Collected comments on Section 5 of draft standard D1 (Part 1)

**Figure 5-14: Mapping QoS onto Channel Access Priority**

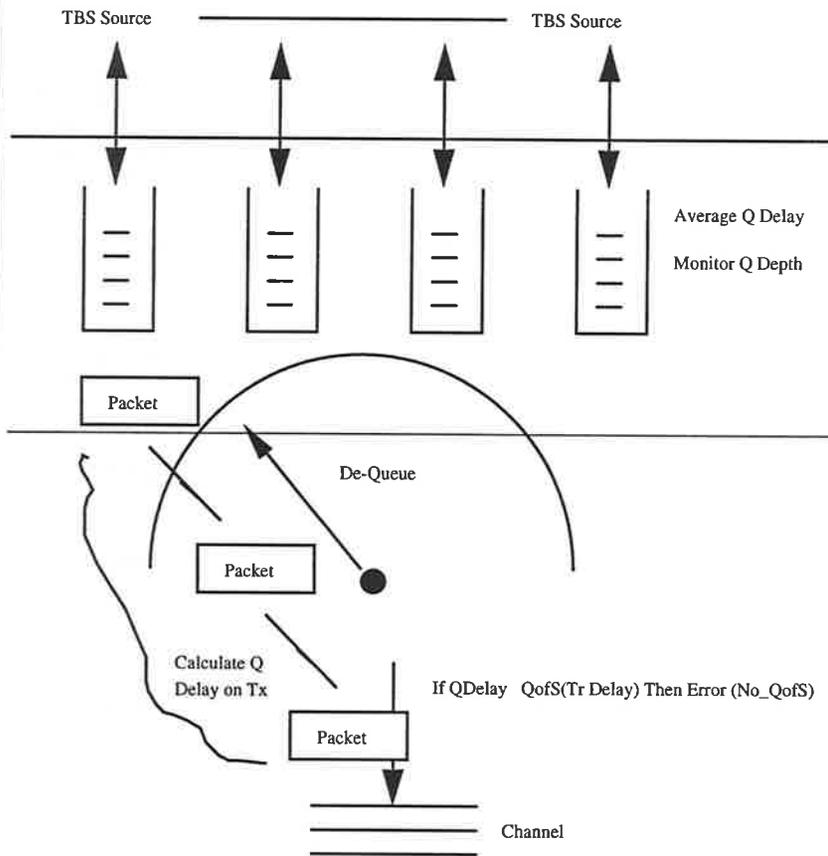
<p>5.2.13</p>	<p>David Bagby</p>	<p>T</p>	<p><b>4. Distributed Time Bounded Service (DTBS)</b></p> <div style="border: 1px solid black; padding: 5px;"> <p>The cmtee has consistently voted against support for a DTBS, therefore the vestiges of that effort must be removed from the draft. A piece of functionality with only partial definition and insufficient cmtee support can not exist in a draft forwarded for sponsor ballot.[DB36]</p> </div> <p><del>An optional Distributed Time Bounded Service (DTBS) may be based on the connectionless mode MAC Service provided by the DCF. DTBS can be characterized as a "best effort" service providing bounded transit delay and delay variance.</del></p> <p><del>DTBS requires a mechanism to map requested Quality of Service (QoS) onto channel access priority. QoS parameters include transit delay, delay variance, and user priority. If the MAC Service user does not explicitly state QoS parameters, the MAC Service provider shall use default values. MAC Service requests that cannot be satisfied are rejected by the MAC Service provider, thus avoiding overload conditions.</del></p> <p><del>DTBS assumes that the MAC Service provides multiple hierarchically independent levels of channel access priority. Hierarchical independence means that increasing load from lower priority classes does not degrade the performance of higher priority classes.</del></p> <p><b>4.— Quality of Service</b></p> <p><del>Associated with each MAC connectionless mode transmission, certain measures of QoS are requested by the sending MAC Service user when the primitive action is initiated. The requested measures (or parameter values and options) are based on a priori knowledge by the MAC Service user of the service(s) made available to it by the MAC Service provider. Knowledge of the characteristics and type of service provided (i.e., the parameters, formats, and options that affect the transfer of data) is made available to the MAC Service user through some layer management interaction prior to (any) invocation of the MAC connectionless mode service. Thus the MAC Service user not only has knowledge of the characteristics of the parties with which it can communicate, it also has knowledge of the statistical characteristics of the service it can expect to be provided with for each MAC Service request.</del></p>	<p>See imbeded comments and annotations</p>

5.2.13	David Bagby continuation	T	<b>7. Channel Access Priority Mechanism</b>	
5.2.13	Geiger	T		
5.2.13	Greg Ennis	T	Replace entire section with "The provision of a Time Bounded Service based upon the Distributed Coordination Function is for further study".	DTBS mechanism is unknown.

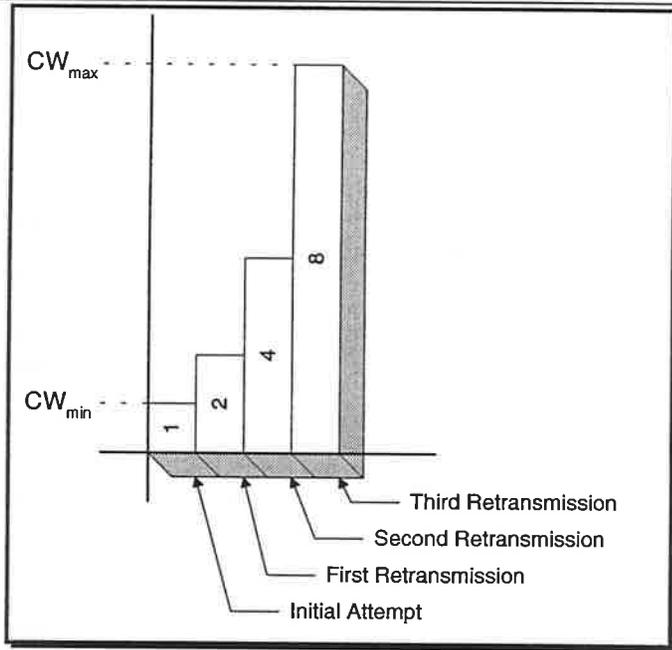
5.2.4 and 5.2.6	D. Johnson	T	<p><b>5.2.4 PCF- IFS (PIFS)</b></p> <p>This PCF priority level shall be used only by the PCF to send any of the Contention Free Period (CFP) frames. The PCF shall be allowed to transmit after it detects the medium free for the period PIFS (PCF Interframe Space), at the start of and during a CF-Burst.</p> <p><u>Alternatively, in cases where regulations require the point coordinator STA to contend for access, the contention window for the PCF begins after the PIFS time.</u></p> <p style="text-align: center;"><b>Figure 5-8: Backoff Procedure</b></p> <p>The wording around the lower right arrow will need to be changed to conform to the revision.</p> <p><b>5.2.6.2 Backoff Procedure</b></p> <p>The backoff procedure shall be followed whenever a STA desires to transfer an MPDU and finds the medium busy.</p> <p>The backoff procedure consists of selecting a backoff time from the equation in Section 5.2.5 Random Backoff Time. <del>The Backoff Timer shall decrement only when the medium is free. The Backoff Timer shall be frozen while the medium is sensed busy. Decrementing the Backoff Timer shall begin/resume whenever a medium free period longer than DIFS is detected. Transmission shall commence whenever the Backoff Timer reaches zero providing the medium is free for a period of DIFS or longer prior to when the timer reaches zero.</del></p> <p style="text-align: center;"><b>Figure 5-8: Backoff Procedure</b></p> <p>This illustration will need to be changed to conform to the revised wording.</p> <p>A station that has just transmitted a frame and has another frame ready to transmit (queued), shall perform the backoff procedure. This requirement is intended to produce a level of fairness of access amongst STA to the medium.</p> <p>The effect of this procedure is that when multiple stations are deferring and go into random backoff, then the station selecting the lowest delay through the random function will win the contention. <del>The advantage of this approach is that stations that lost contention will defer again until after the next DIFS period, and will then likely have a shorter backoff delay than new stations entering the backoff procedure for the first time. This method tends toward fair access on a first come, first served basis.</del></p>	<p>Allows an IEEE STA with the DCF to operate with the spectrum etiquette of Part 15.321 and thereby operate in the UPCS asynchronous sub-band.</p> <p>Although the currently specified back-off procedure favors STAs which have been in back-off longest, it cannot be implemented on the basis of power detection. An etiquette cannot determine when a retransmission is needed. Further, typical user information transfers normally consist of multiple frames, thus the delay to the user is more dependent on the average delay each frame experiences. This average delay will be no longer with the proposed change.</p> <p>It retains the definition of the PIFS for those cases where PCF operation is permitted.</p> <p>This is one of the reasons for the no vote.</p>
